ULNRC-3071

CALLAWAY PLANT

REVISION TO TECHNICAL SPECIFICATIONS 3/4.8.2.1,  
3/4.8.2.2, 3/4.8.3.1 AND 3/4.8.3.2 ELECTRICAL POWER SYSTEMS  
D.C. SOURCES AND ONSITE POWER DISTRIBUTION

Figure 1

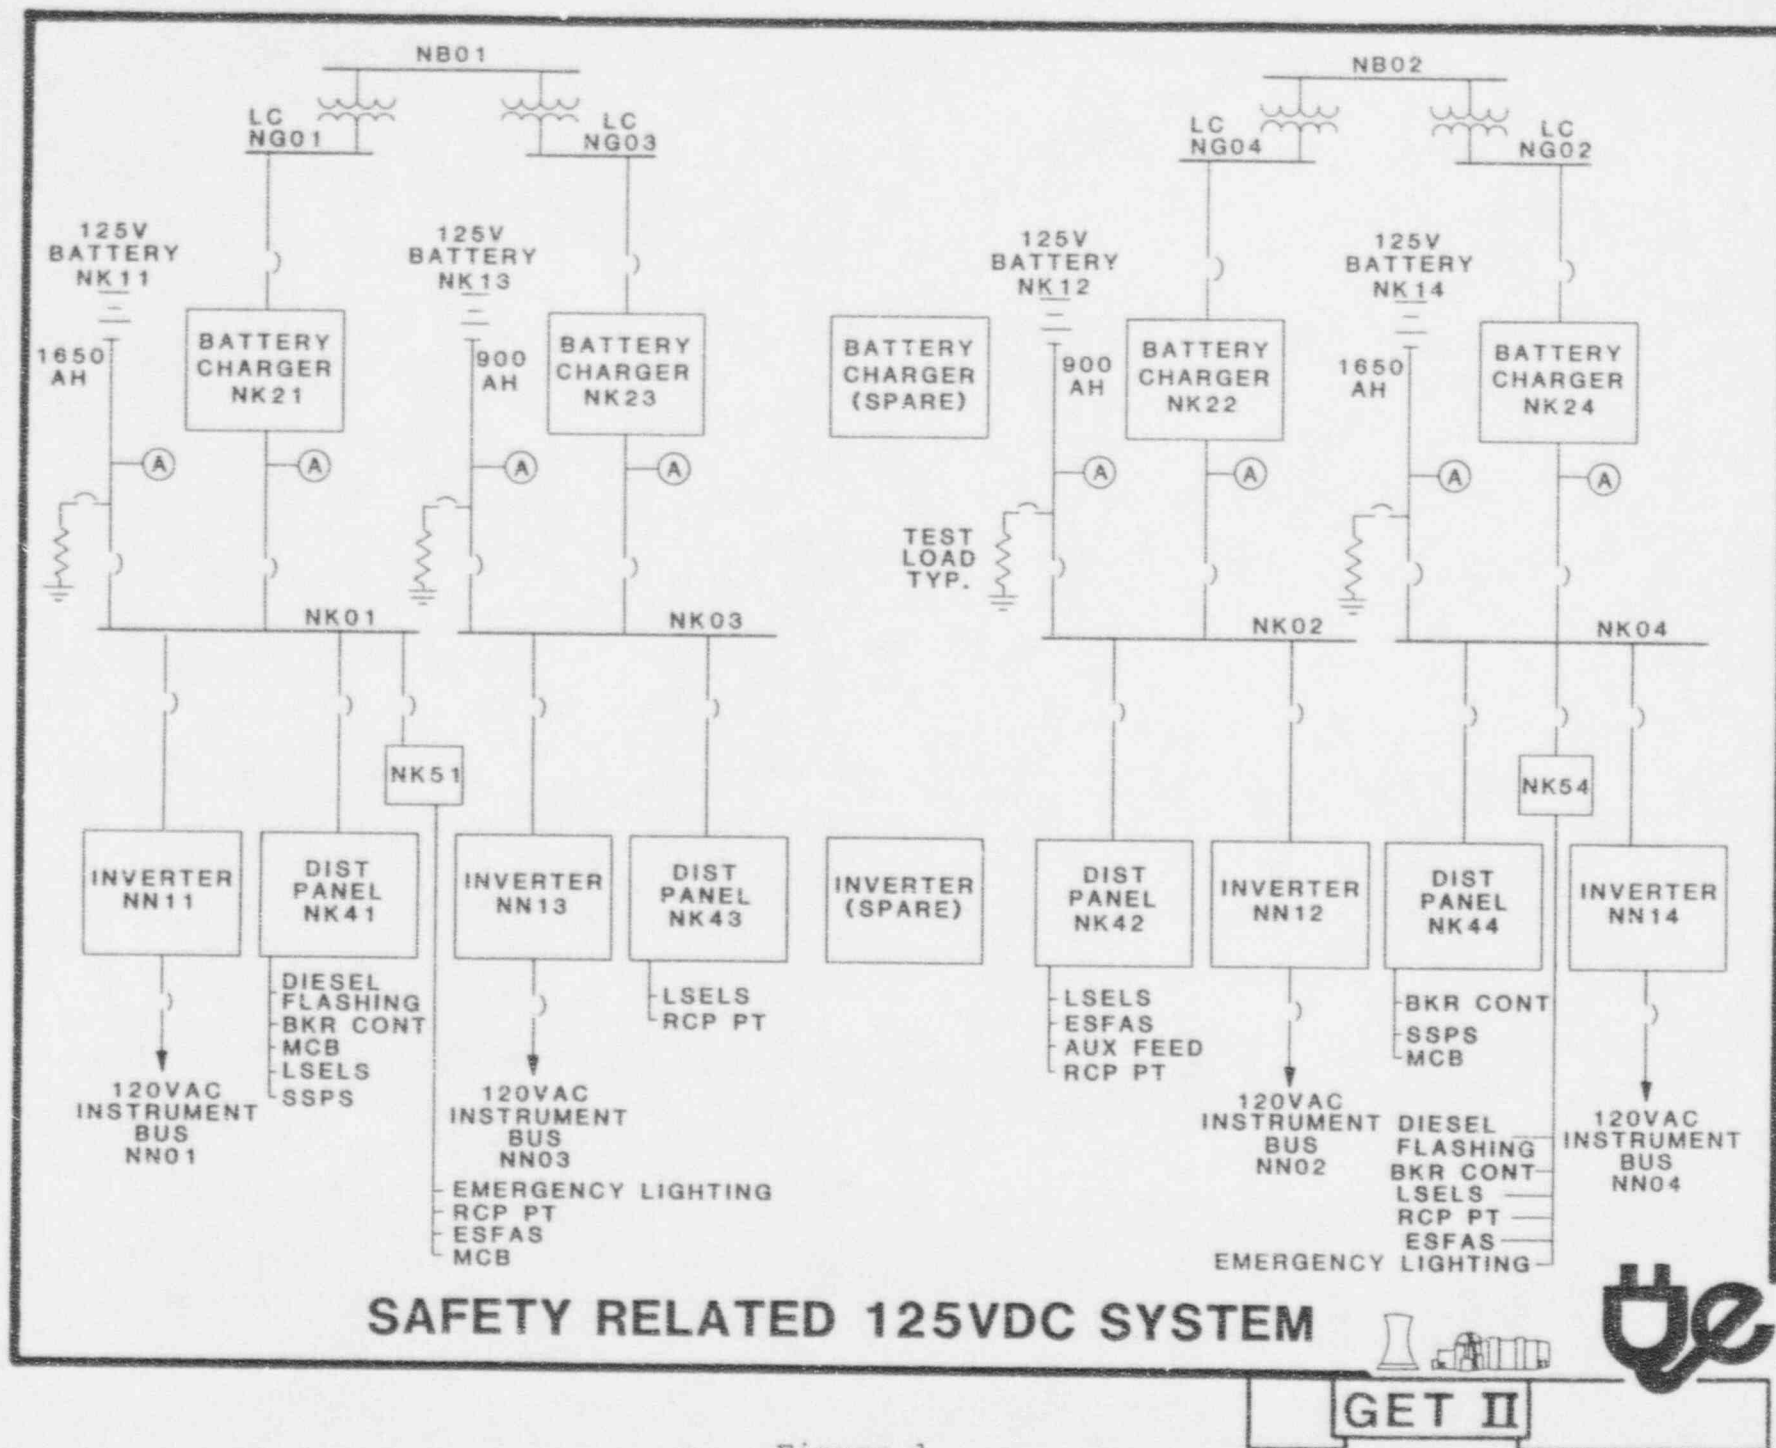
Figure 1 is a simplified drawing of the existing safety-related 125-volt D.C. system at Callaway. This figure shows the connections from the two 4160-volt A.C. Emergency Busses (NB01 and NB02) through the four 480-volt A.C. Emergency Busses (NG01/NG03, NG04/NG02). The NG Busses supply power to the four full capacity chargers (NK21/NK23, NK22/NK24). Each charger supplies a Class 1E 125-volt D.C. bus (NK01, NK03, NK02, and NK04) and an associated 125-volt battery bank (NK11, NK13, NK12, or NK14).

FIGURE 2

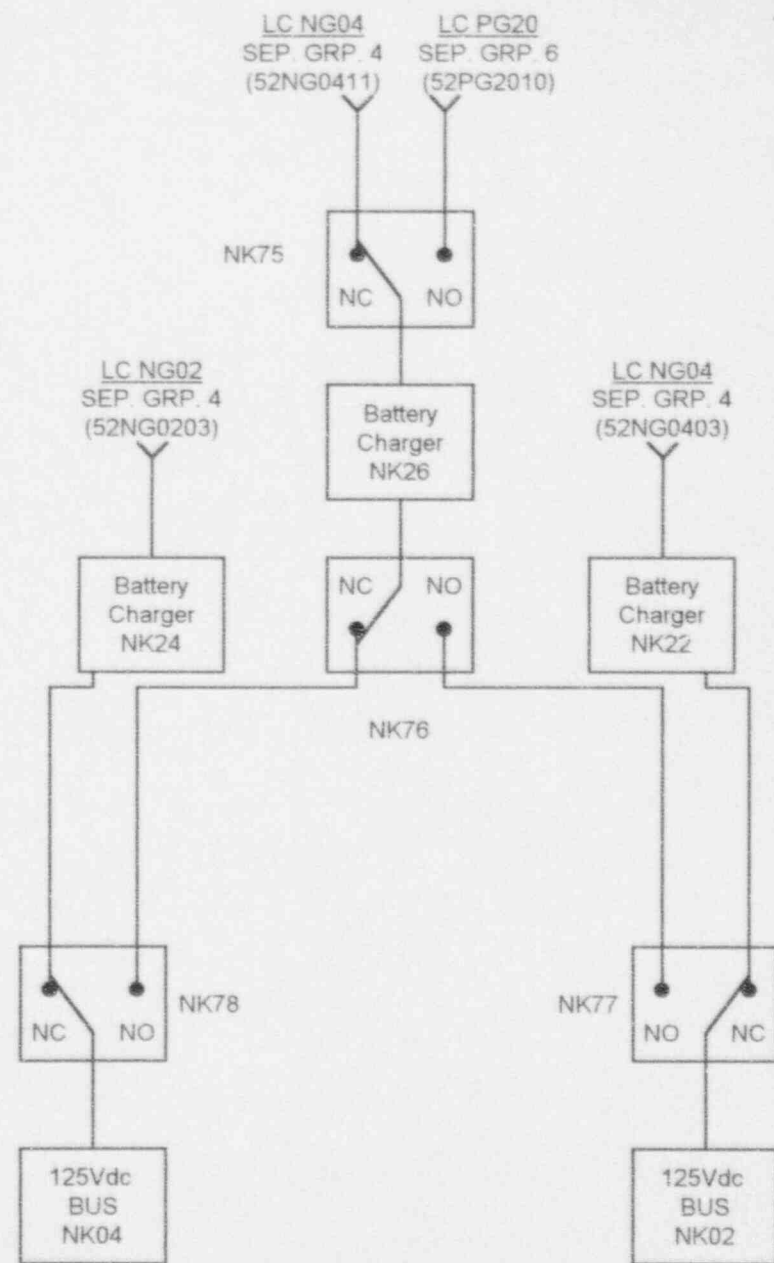
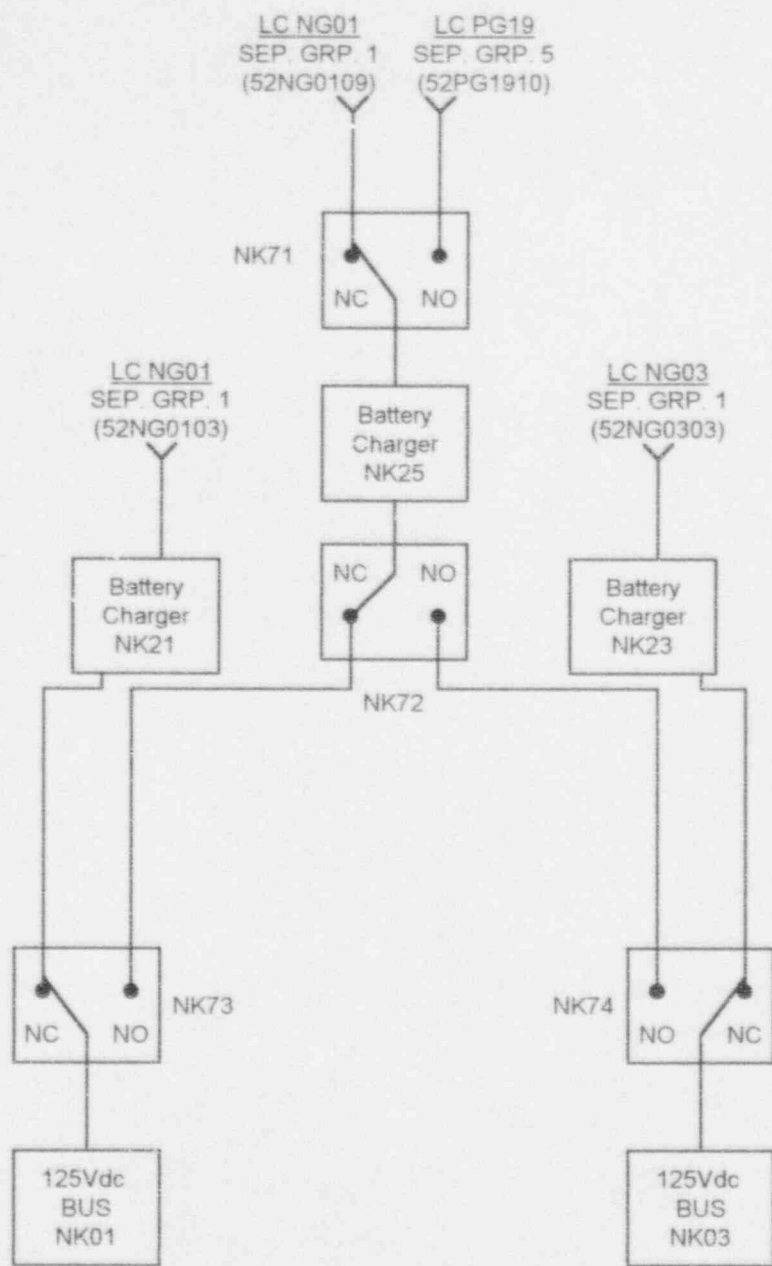
The current spare battery charger will be permanently installed as a swing charger for the 125-volt D.C. Busses NK01 and NK03. Another charger is being procured and will be installed as a swing charger for 125-volt D.C. Busses NK04 and NK02. Each Class 1E D.C. power subsystem will then consist of one 125-volt battery, one primary battery charger, one UPS, distribution switchboards, a shared swing battery charger, and swing battery charger transfer switches. The battery chargers for D.C. subsystems 1 and 3 will supply 480-volt A.C. power from different Class 1E busses of Load Group 1 while their shared swing battery charger will supply 480-volt A.C. power from either a Class 1E bus of Load Group 1 or a Non-class 1E bus from load group 5. Similarly, the battery chargers for D.C. subsystems 2 and 4 will be supplied 480-volt A.C. power from different Class 1E busses of Load Group 2 while their shared swing battery charger will supply 480-volt A.C. power

Two swing battery charger subsystems will be provided for the Class 1E D.C. power subsystems. One for use with Class 1E D.C. subsystems 1 and 3 and the other for use with Class 1E D.C. subsystems 2 and 4. The swing chargers are permanently connected to their respective Class 1E D.C. power subsystems via manually controlled electrically operated transfer switches. In the event of a failure of a primary battery charger, the respective swing battery charger can be quickly aligned to provide power to the affected D.C. power subsystem. Therefore, the malfunctioning equipment may be repaired without imposing long-term disruption of the system. Once the swing battery charger is aligned to a given D.C. power subsystem all of the required annunciated trouble conditions are monitored on the swing charger and an annunciator window on the main control boards is lit to alert the control room staff that a swing charger is in use.

Figure 3

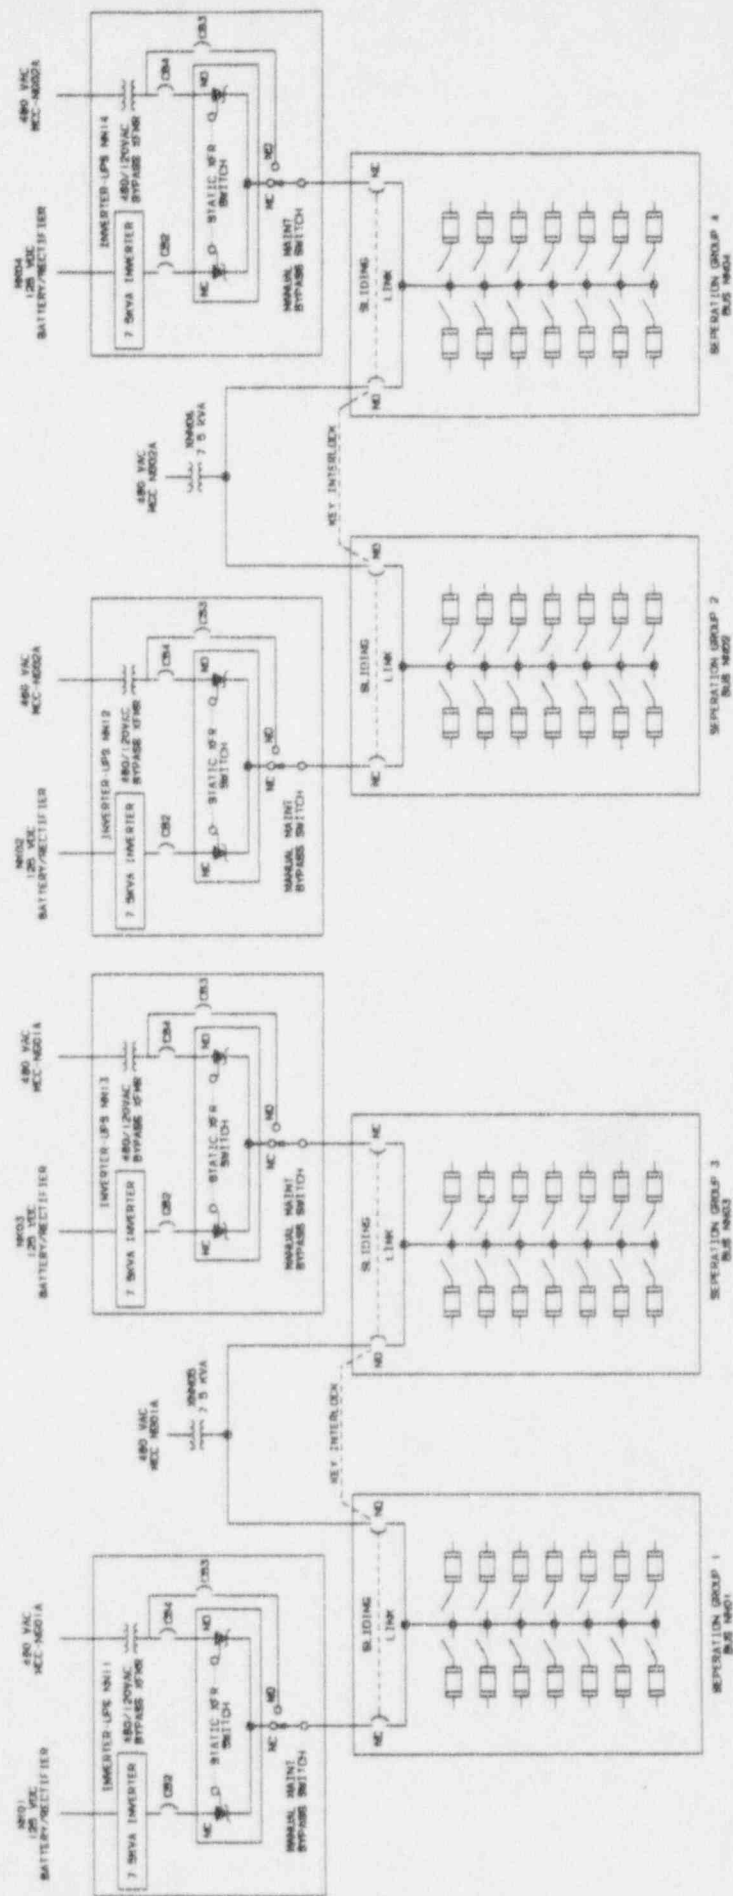
The second modification is an upgrade to the existing inverters (NN11, NN13, NN12, and NN14). Each existing inverter will be replaced with a state-of-the-art uninterruptable power supply (UPS) consisting of an inverter, a standby 480 to 120-volt isolation transformer, and an automatic transfer switch. The gating and synchronization circuit of the new UPS will monitor the plant A.C. system and keep inverter output in-phase and at the same frequency as the backup supply. This allows make-before-break transfers so that the bus is not de-energized at any time. The load will be automatically transferred to the backup supply when any one of the following conditions is present:

1. Undervoltage detected on the output of the inverter SCR bridge.
2. Undervoltage detected on the output of the inverter.
3. Manual initiation.
4. Output overcurrent.

Each of these conditions will be locally alarmed and will generate a main control board annunciator and plant computer alarm. Technical Specification Action 3.8.3.1 or 3.8.3.2 will be entered when loads are transferred to the backup supply. Figure 3 provides a schematic of this design change. This modification requires no Technical Specification changes and is being performed under the provisions of 10CFR50.59. It will provide improved plant reliability in the event of inverter problems or failures.
